# Rezoning Transportation Analysis

Petition Number: 2024-004

**From: Jake Carpenter, PE**  
Jacob.Carpenter@charlottenc.gov  
980-221-5675

Date	Description
2-21-24	First Review (JP)
3-20-24	Second Review (JP)
4-23-24	Third Review (JP)

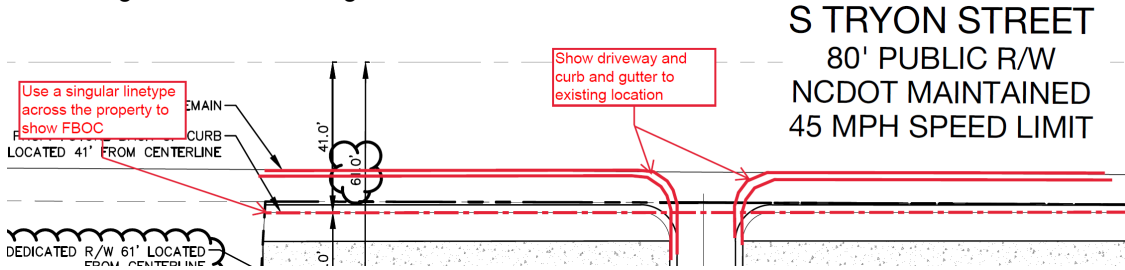
- 4. ~~Outstanding Comment 3.20.24:~~ In coordination with NCDOT, revise site plan and conditional notes to install a right turn lane into the site with 50' of storage.
